Highways England Planning Response (HEPR 16-01)

Formal Recommendation to an Application for Planning Permission

Council's Reference: 16/01401/OUTEIA

Subject: Planning application 16/01401/OUTEIA - Newlands Park - Luton

Figure 2/6.3 Diverge Lane Layouts for use with Figure 2/5

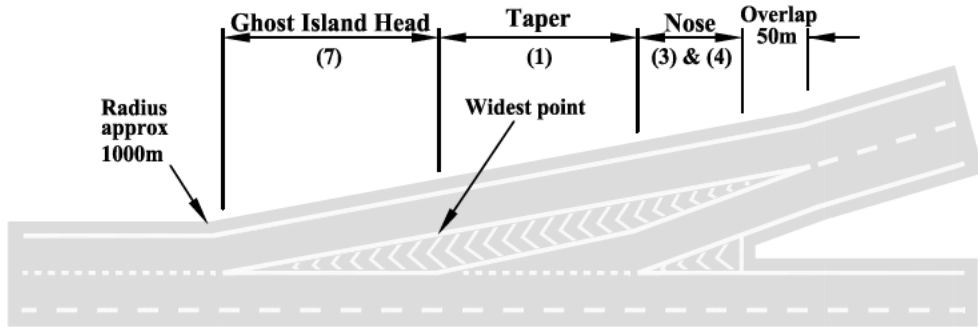
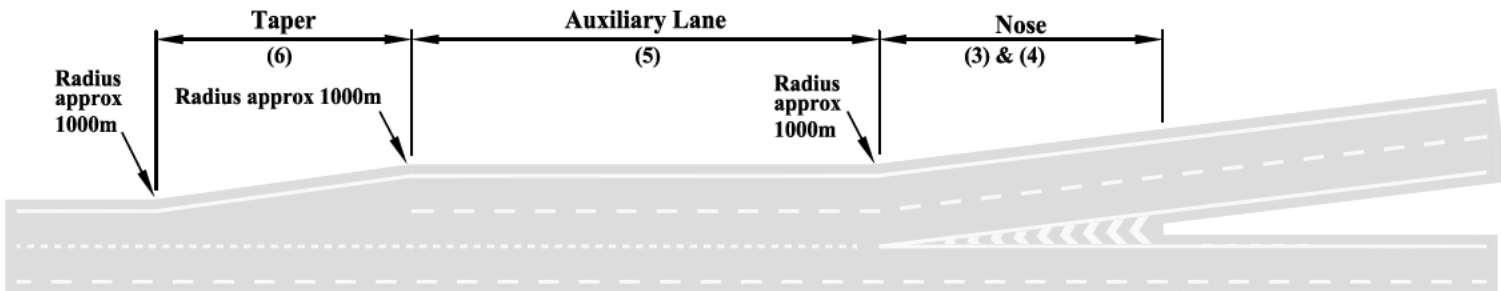
Our thinking behind the proposed layout took account of DMRB Figure 2/5 MW (see attached PDF), which recommends typical diverge lane layouts based on mainline and diverge flows. This figure/graph recommends Diverge Layout D as per our proposal. However, as you suggest below this layout would require existing Gantries to be relocated and/or new Gantries to be installed due to the diverge forming further upstream and therefore increased abortive costs if a more strategic option comes to light in the future. The proposed design submitted to date goes beyond mitigating the development impact and includes for the full upgrade of the diverge to meet DMRB recommendations (currently the diverge layout falls short of this).

- Convert the diverge arrangement on the northbound off-slip to match ‘DMRB Volume 6, Section 2, Part 1 TD 22/06 Figure 2/6.3 Layout D’, where the existing slip lane is extended into the inside lane of the M1 mainline upstream of where the existing slip lane starts. This layout involves a lane drop, the proposals (provided on a drawing within TAA3) include an immediate lane gain downstream of the off-slip.

Type D Ghost Island Diverge for Lane Drop (TD 22/06 Figure 2/6.3)

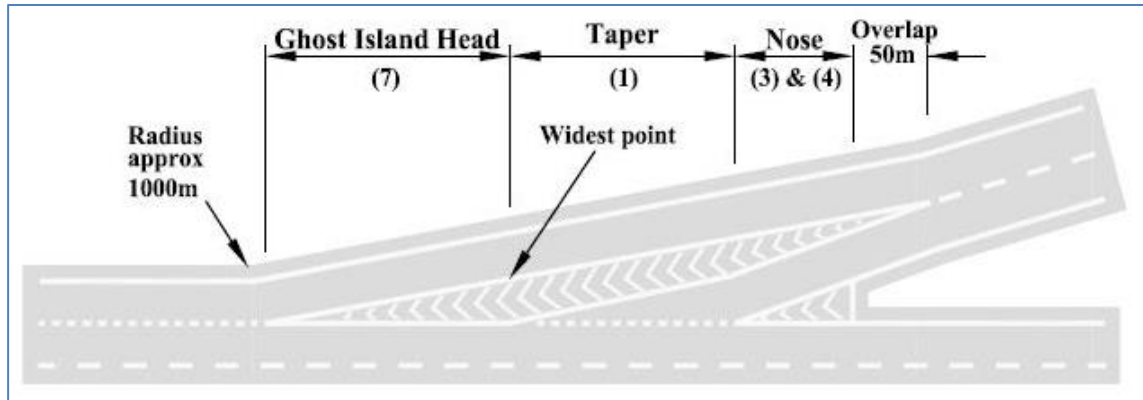
3.1. From the information provided within the PBA Transport Assessment – Addendum Report 03 (Sketch 32444/5501/SK01), the proposals seek to change the existing J10 diverge from the current dual 4 lane motorway with a Type B Parallel Diverge to a dual 4 lane motorway approach with a Type D (Option 1) Ghost Island Diverge for Lane Drop.

Screen print from Sketch 32444/5501/SK01 showing the proposed ½ mile ADS position

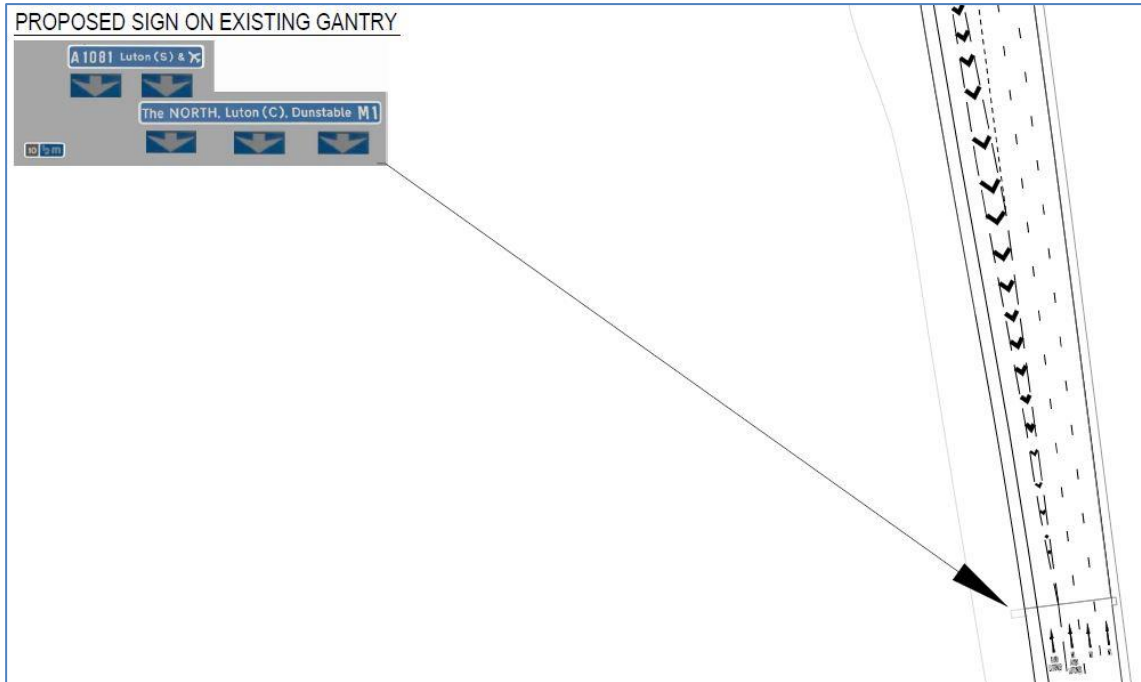
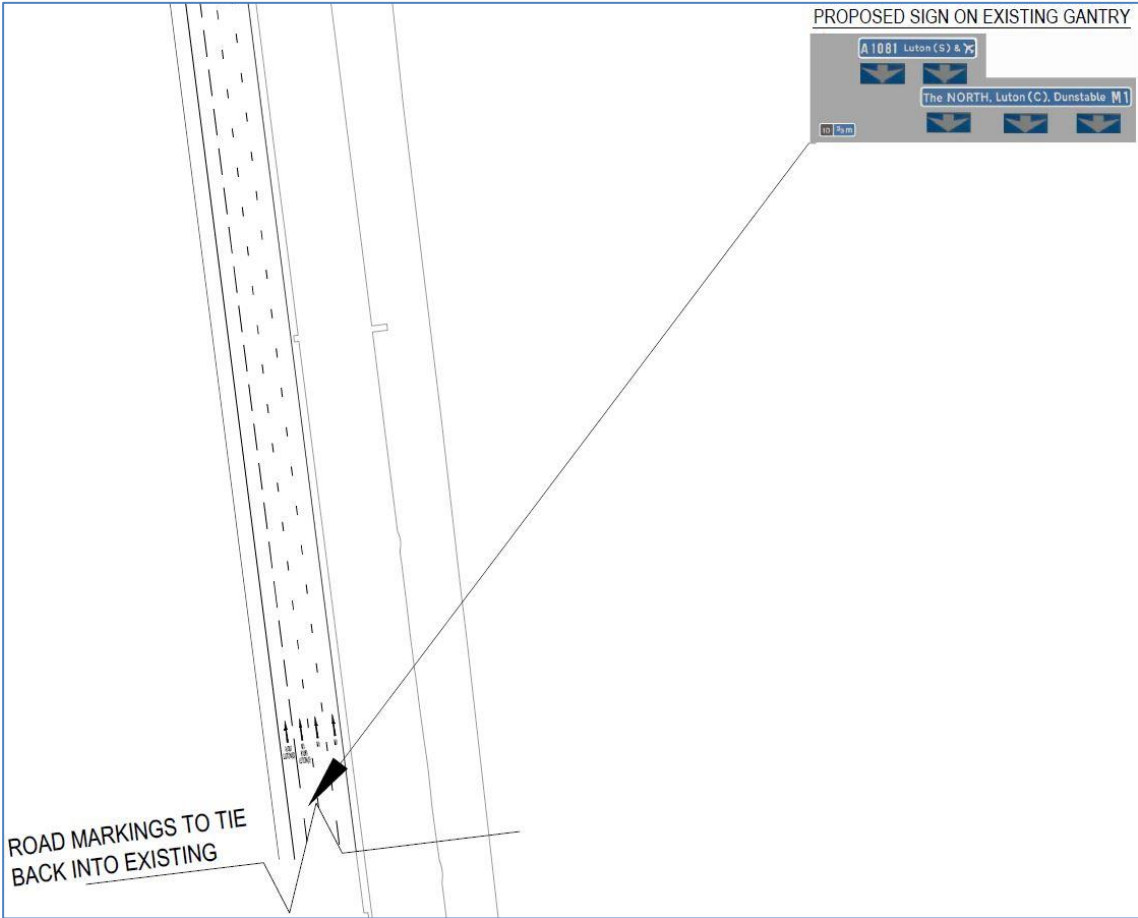
3.2. The proposals provided seek to amend the existing gantry mounted Advance Direction Signage on approach to the junction with new $\frac{2}{3}$ mile and $\frac{1}{2}$ mile signs.

3.4. The proposed layout and signing locations are presented within the PBA Transport Assessment – Addendum Report 03 as Sketch 32444/5501/SK01. A copy of this is provided in Appendix A and in the following two images. As can be seen from the first image, the proposals seek to locate the proposed ½ mile ADS sign at the beginning of the ghost island head where it is assumed the current J10 final ADS is located on an existing gantry. The proposals seek to locate the proposed ⅔ mile ADS on what is assumed to be the existing J10 ⅓ mile gantry (refer to second image).

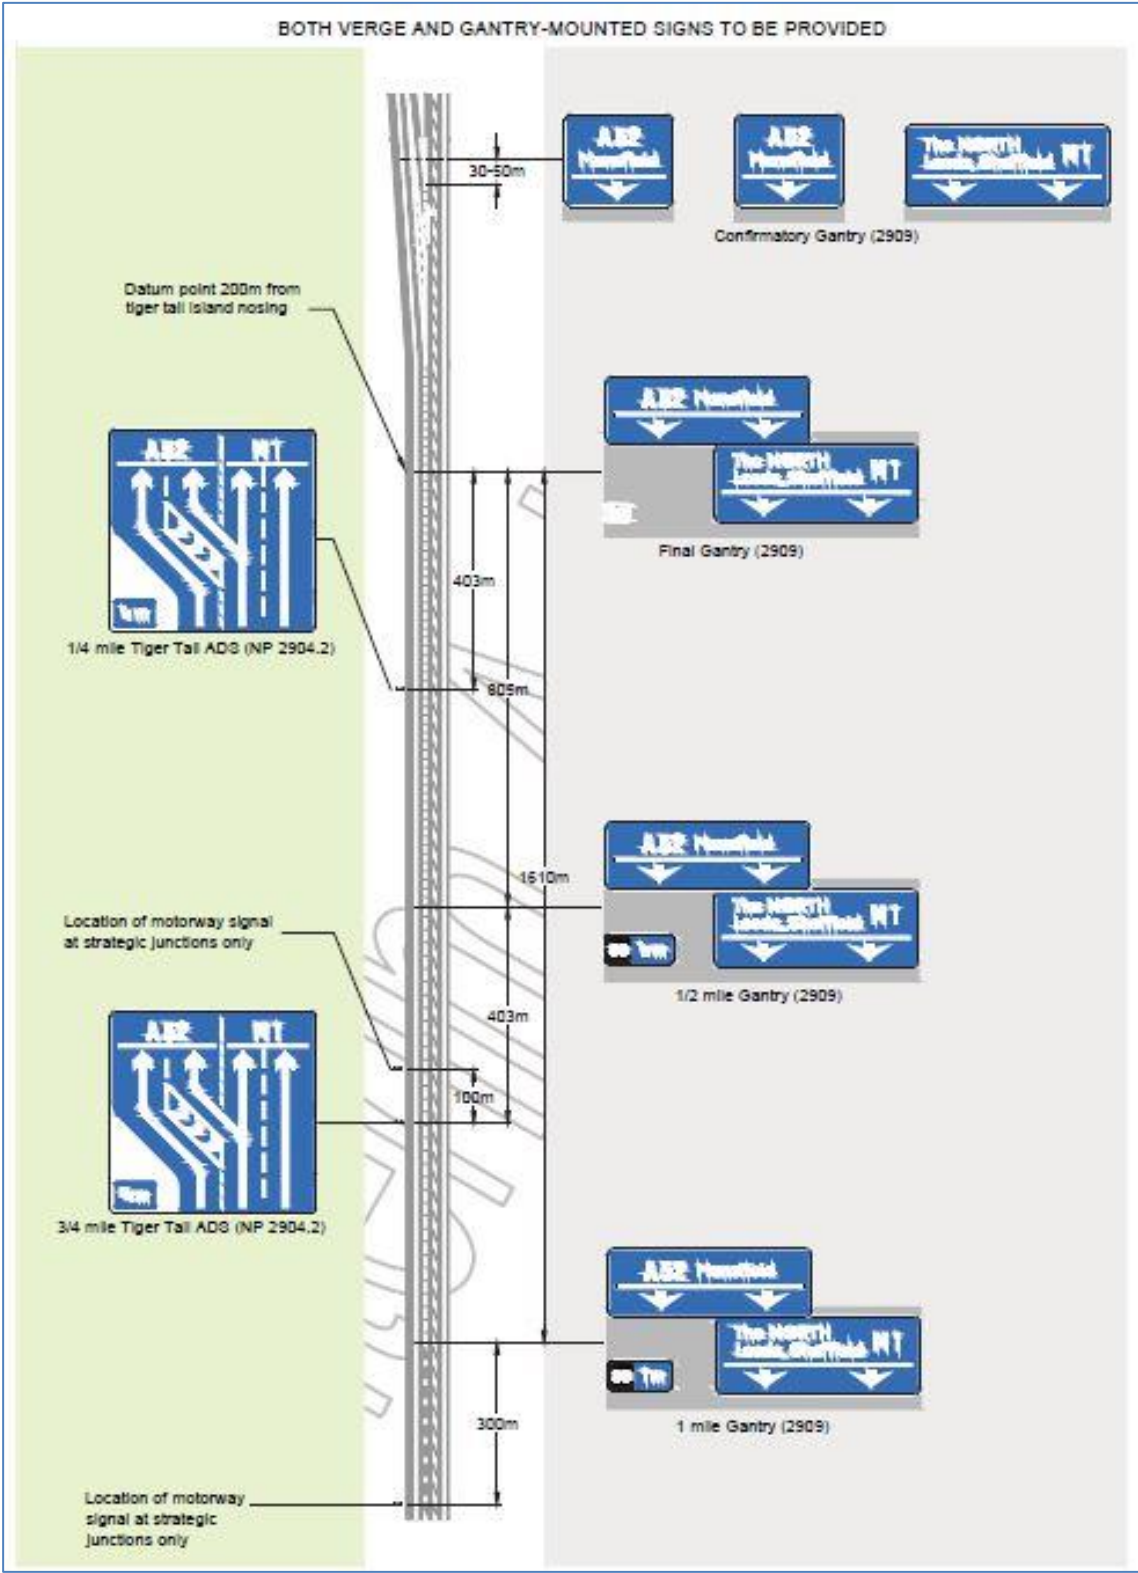
- 4.1. TD 22/06, para 5.37 states that *'For grade separated junctions two or three advance direction signs must be provided. These are to be located at the start of the diverging lane, ½ mile (⅓ mile in difficult circumstances) from the junction and additionally for motorways and some all-purpose roads 1 mile (⅔ mile in difficult circumstances) from the junction. On motorways either a confirmatory gantry sign or a route number confirmatory sign (TSRGD diagram 2910), located at the back of the nose, must be provided'*. This is a mandatory section within TD 22/06 and failure to comply would require a departure.

The proposals submitted do not conform to the standards set out in TD 22/06 as a final ADS sign has not been included in the proposals. In addition, it is unclear what the proposals are for the existing route confirmatory sign, which is required under TD 22/06. The existing route confirmatory sign gantry currently displays a 4 lane motorway. Under the proposals provided the motorway is being amended to a 3 lane motorway and therefore the existing route confirmatory sign will no longer be valid.

IAN 144/16, Figure 4.4

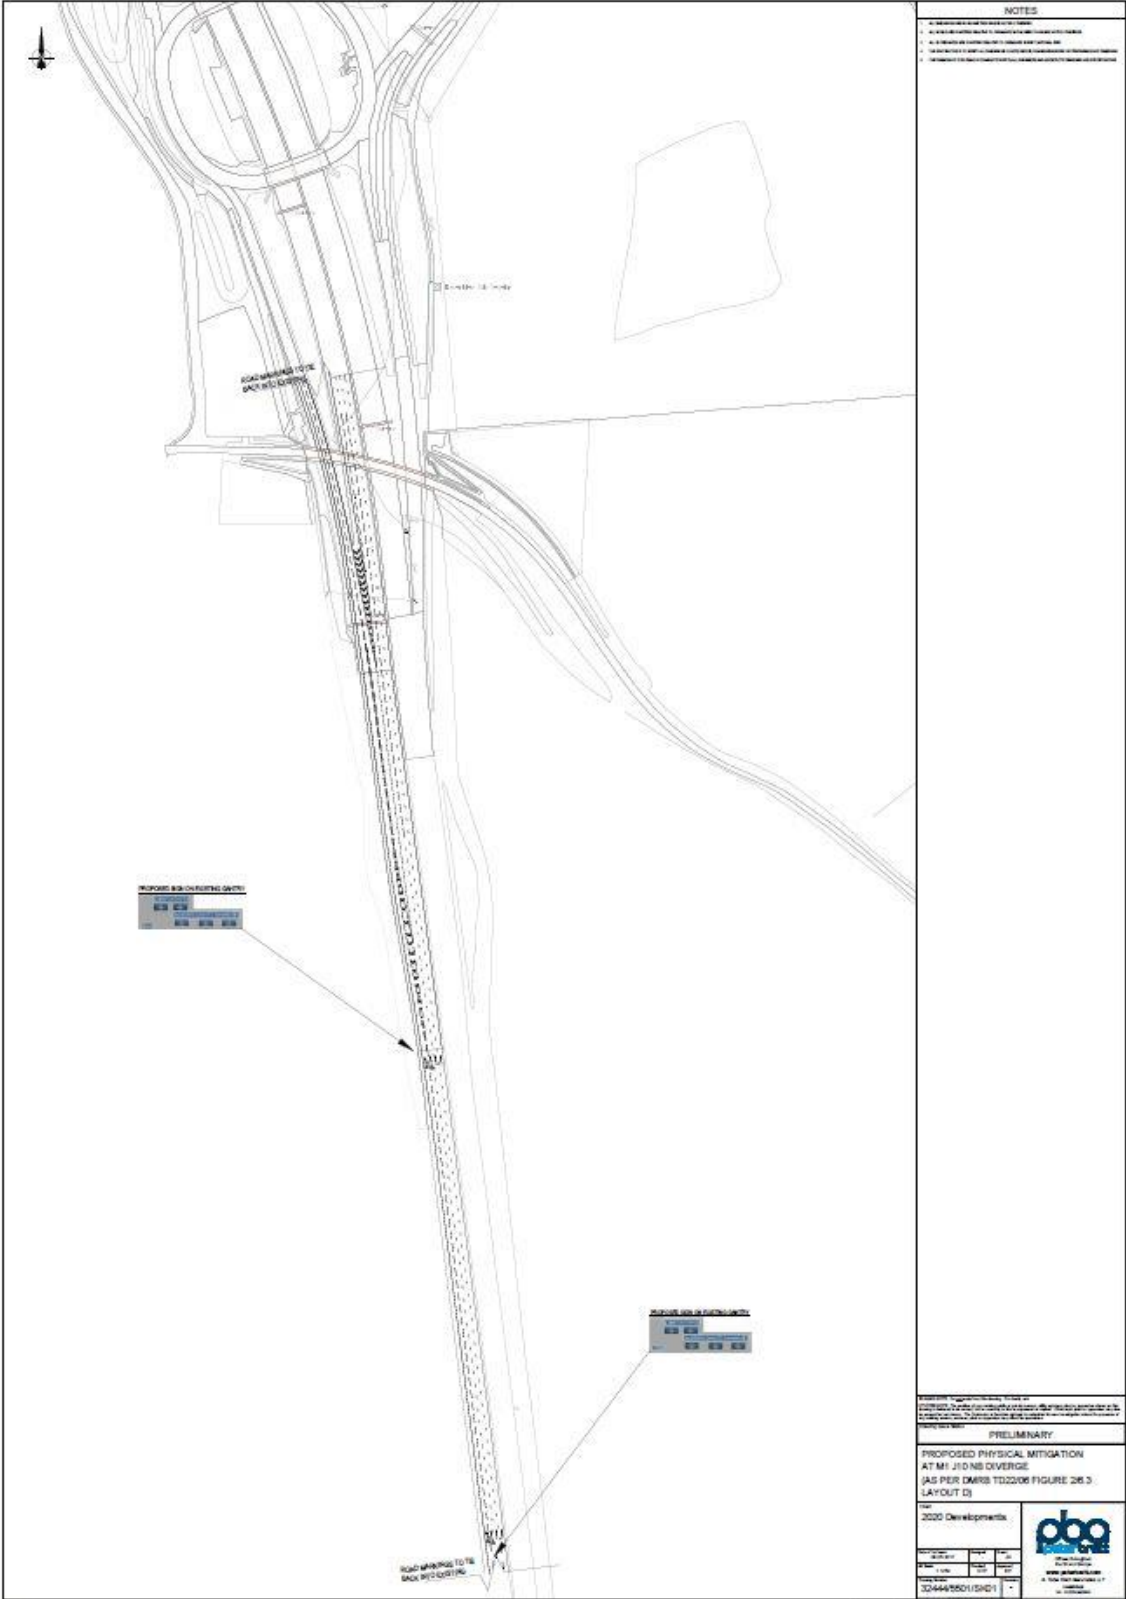
- 4.10. IAN 149/11, Figure 5-12 provides a diagram detailing the provision of the gantry mounted signs required for a Type D diverge.
- 4.11. AECOM have reviewed the proposals against IAN 144/16 which details the full directional signing that should be provided on approach to a motorway grade separated junction. Section 4 deals with Tiger Tail diverge arrangements and the proposals presented on Sketch 32444/5501/SK01 can be classed as a Standard Tiger Tail Ghost Island with Lane Drop and Taper Diverge. The directional signing layout for this arrangement is discussed in Section 4.6 and Figure 4.4 of IAN 144/16.

- 4.13. In addition, and as specified in TD 22/06, para 2.51, due to the proposed diverge being a lane drop ghost island (tiger tail) diverge with taper diverge, two additional verge mounted Tiger Tail signs must also be provided at $\frac{3}{4}$ mile and $\frac{1}{4}$ mile. The inclusion of these signs is important to ensure that users understand the layout of the junction and adopt the correct lane discipline on approach to reduce the likelihood of accidents. As previously stated the proposals submitted do not conform to these requirements.

- 5.2. The designer (PBA) should review the proposed signing provision for the amended northbound M1 J10 diverge to provide direction signing in accordance with the current standards. The designer (PBA) should ensure that the proposed sign faces are designed in accordance with the current version of the Traffic Signs Regulations & General Directions (currently 2016) and the Traffic Signs Manual Chapter 7 (currently 2013).

- 5.3. The designer (PBA) should review the layout of the proposed northbound M1 J10 diverge against the positions of the existing gantries on approach to the junction to ascertain whether the advance signing required (1 mile, ½ mile and final) can be located at the correct distances from the diverge 'Exit Datum Point'.
